**SAFETY  
RECALL**

**SR17-28A**

DATE :	December 2017	SECTION :	18 BODY
SUBJECT:	FUEL TANK CRADLE HARDWARE

Revision: A  
2017-11-30

Figure 3: H Series Cradle Mounting Locations

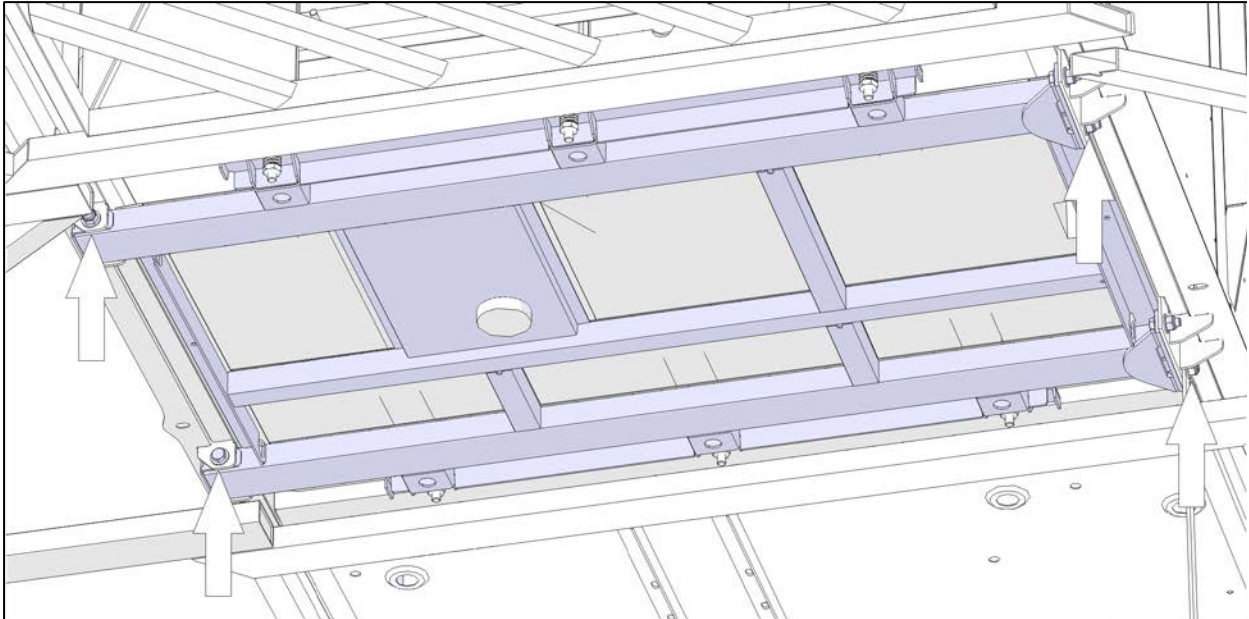
On vehicles affected by this recall, one end of the fuel tank cradle is attached to the frame at two locations. At these locations, a gap exists between the structural lugs and the cradle support tubing. Over time, this gap can cause the bolt torque to loosen, which could compromise the integrity of the bolt. If the cradle attachment points (i.e. both bolts) fail, the fuel cradle, complete with the fuel tank, can drop to the ground.

The vehicles will have the attachment points prepared, shimmed, and the hardware replaced.

Figure 4: Longitudinal Mounting Screws (4 locations)

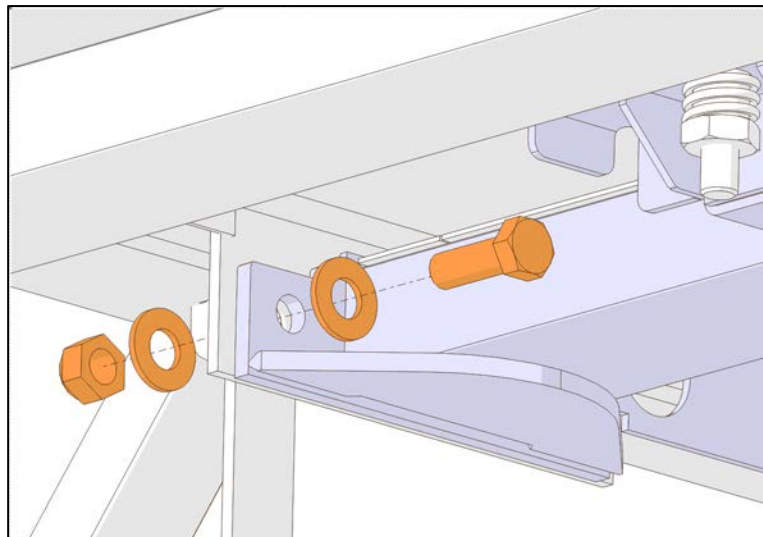
4. Remove and replace the longitudinal mounting screws one at a time. (4 locations)

5. Install new hardware:

**500806**, Screw M12 35mm

**500811**, Nut M12

**500958**, Washer 2x

6. Tighten to **82 lb-ft**. Apply torque seal marks

Figure 5: Transversal Mounting Screws (2 locations)

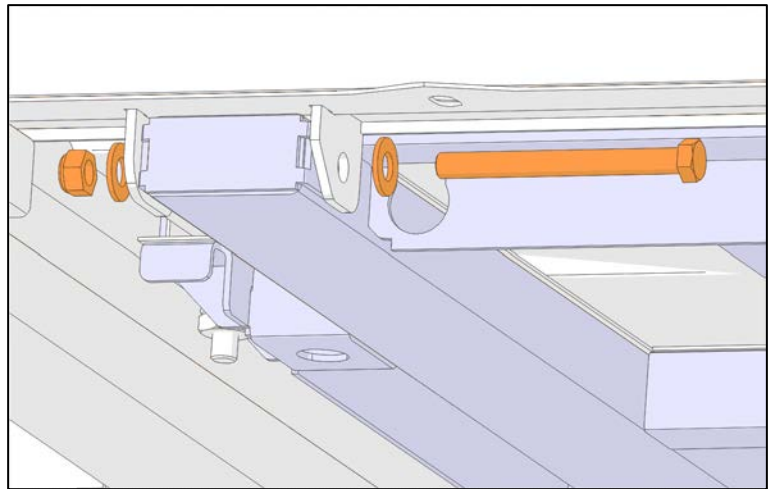
8. Remove one transverse mounting screw.
9. It may be required to remove static straps.

Figure 6: Mounting Lugs

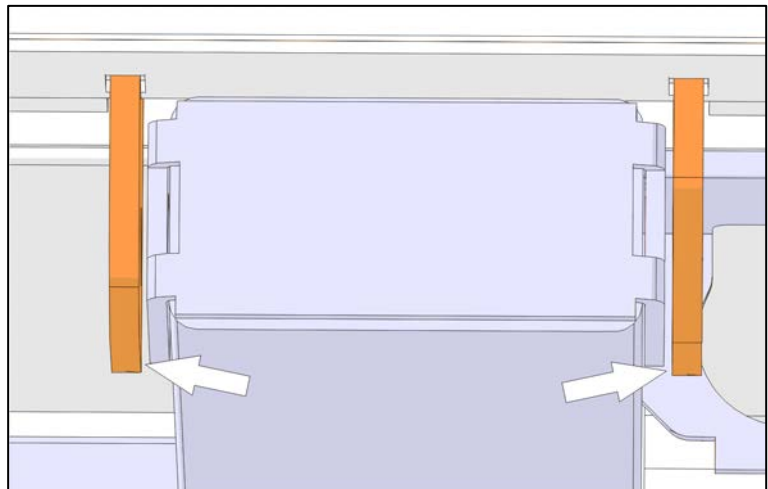
10. The mounting lugs on the vehicle frame may be bent slightly inward. Bend them slightly outward to make them straight with a hammer and chisel.

Mounting lug geometry may vary across model years.

11. Blow clean and try to insert one shim between the mounting surface of the cradle beam and the ear.

Figure 7: Cradle Tubing Mounting Surface

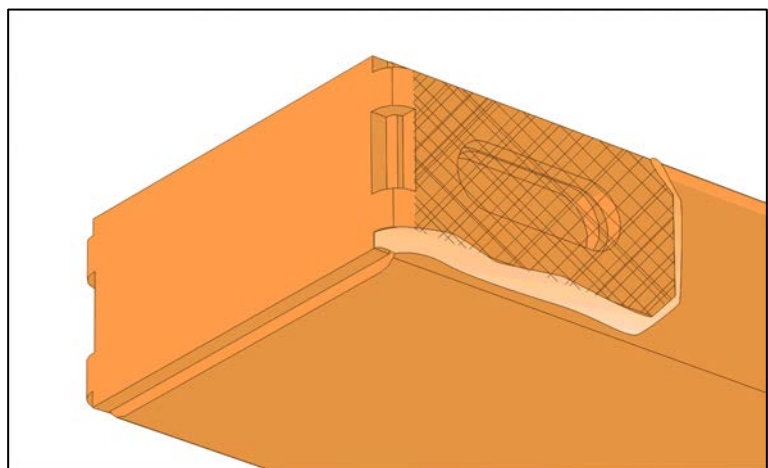
12. If you feel interference while inserting the shim, the contour weld on the cradle tubing may need to be lightly ground down in this location with a thin cutting wheel to have a flat surface for the shim. (Figure 7).

13. Clean and dry the mounting surfaces.

Figure 8: Screw and Shim Installation

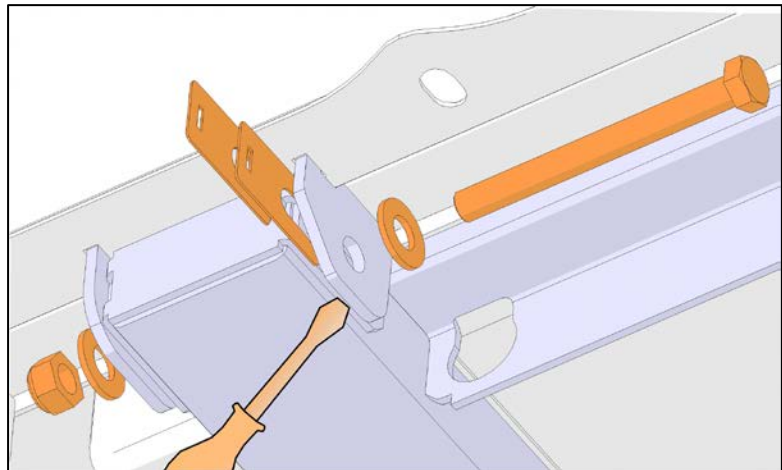
15. Insert the required amount of shims **030082** or **030083** between the mounting lugs and the cradle tubing.

**Note:** To ease shim insertion, you may need to pry lug and tube open with a flat head screwdriver. (Figure 8) Gently tap the shim with a hammer.

Shim arrangement will vary depending on vehicle series and model year.  
Shims may be stacked only on one or both sides of the tube.  
In all situations the shims should be snug between mounting ear and tube.
